Legacy Holladay Park Central Lab

Proposal for a Two-Story, 62,000 Square Foot Clinical Laboratory for Legacy Health

LEGACY HOLLADAY PARK
CENTRAL LABORATORY RELOCATION PROJECT
Superblock Requirements
November 27, 2012

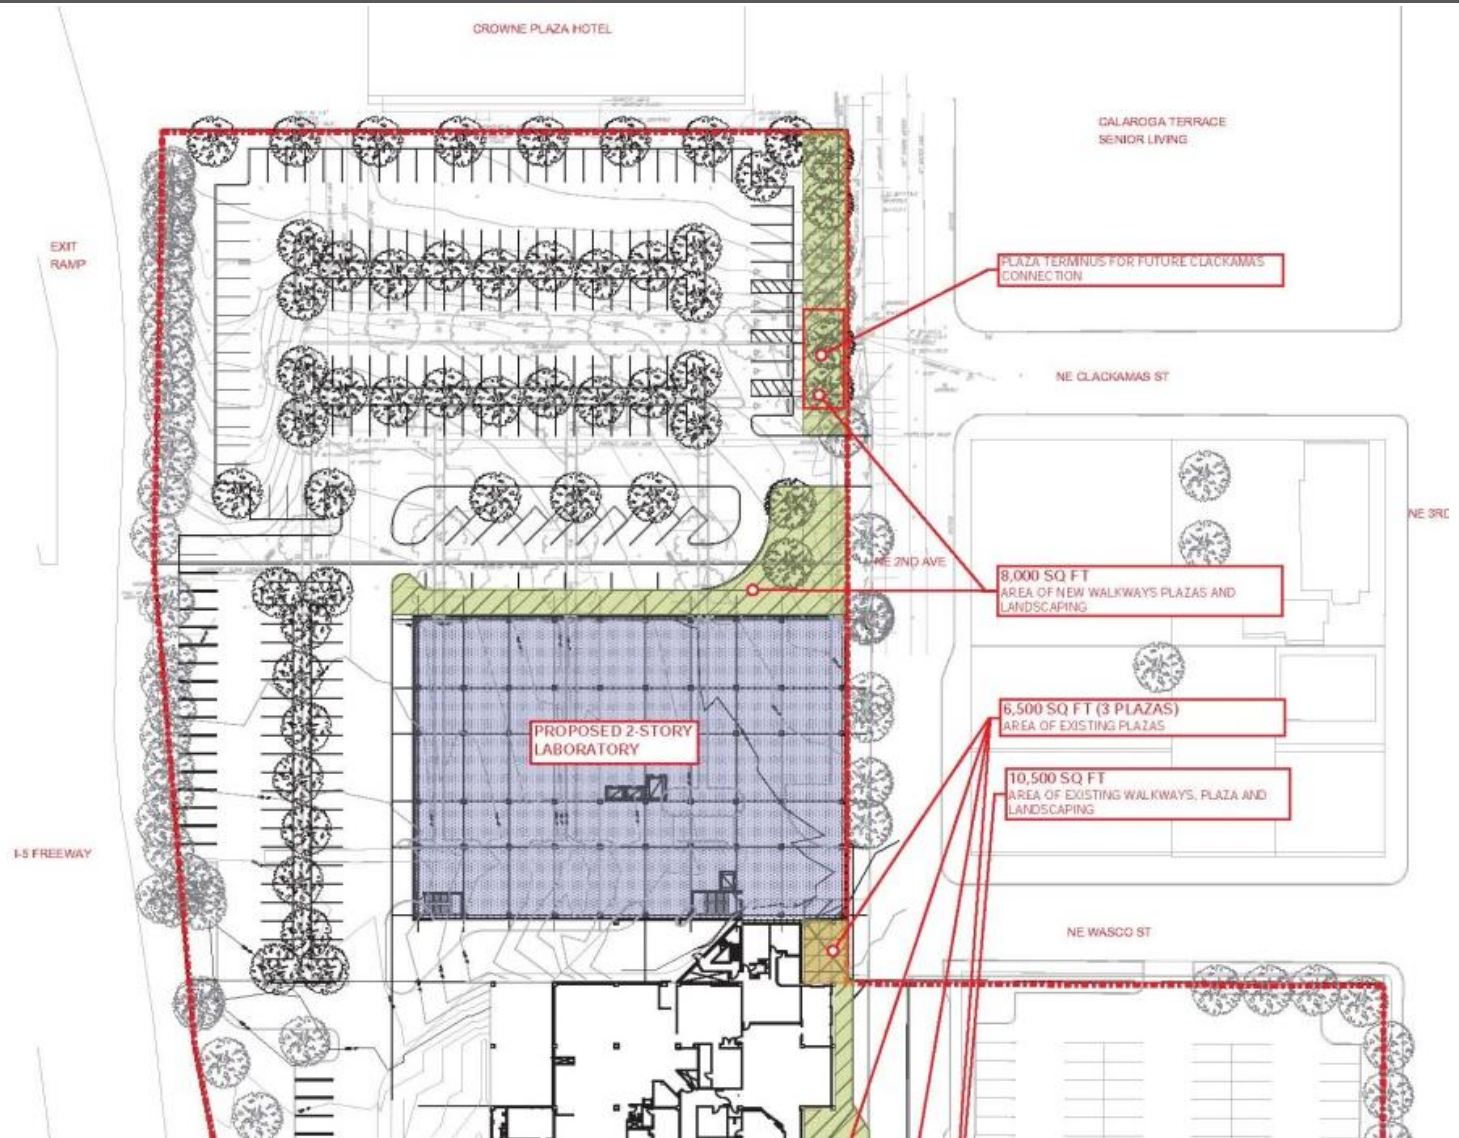
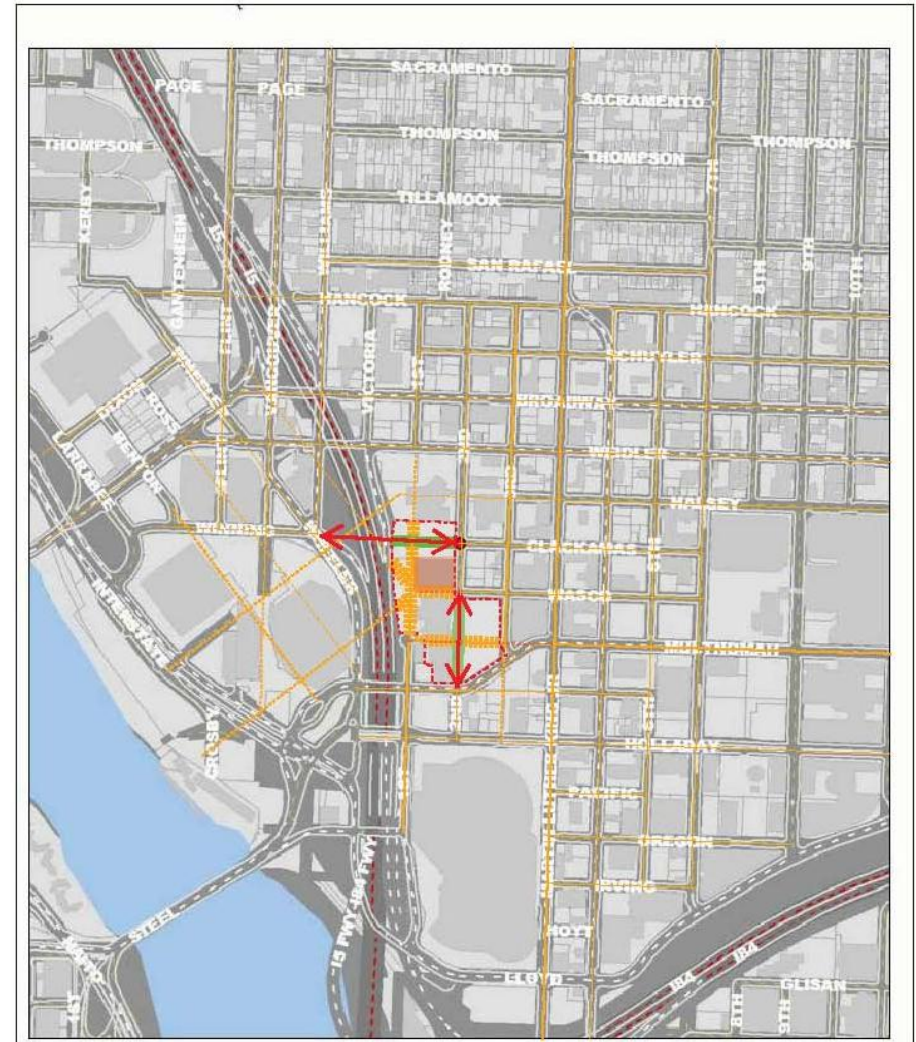
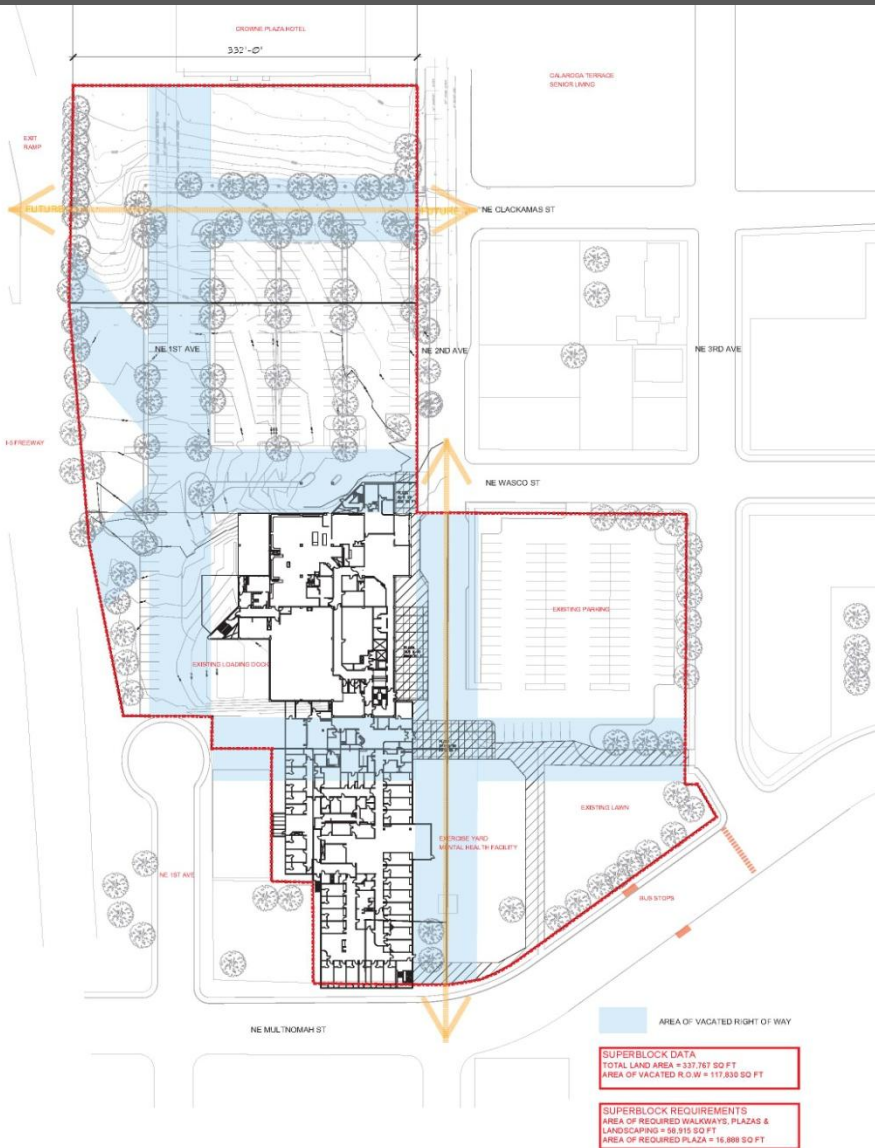
General Comments

A majority of the Commission concluded the following:

- Master Plan is necessary (and required) to show how the walkways and the public spaces would be connected throughout Legacy's Superblock site.
- The City should consider reducing the Superblock requirements, given the large amounts of vacated streets on the site, or another compromise so long as the intent of the Superblock requirements could be met.
- City and Applicant need to work together toward a creative approach to provide the Superblock improvements and meet Legacy's goals for the site with consideration of the future east-west connection along Clackamas identified in the N/NE Quadrant Plan.
- An interim use/development of the area required for the Superblock improvements could be considered, such landscaping or parking, while deferring the actually pedestrian and public
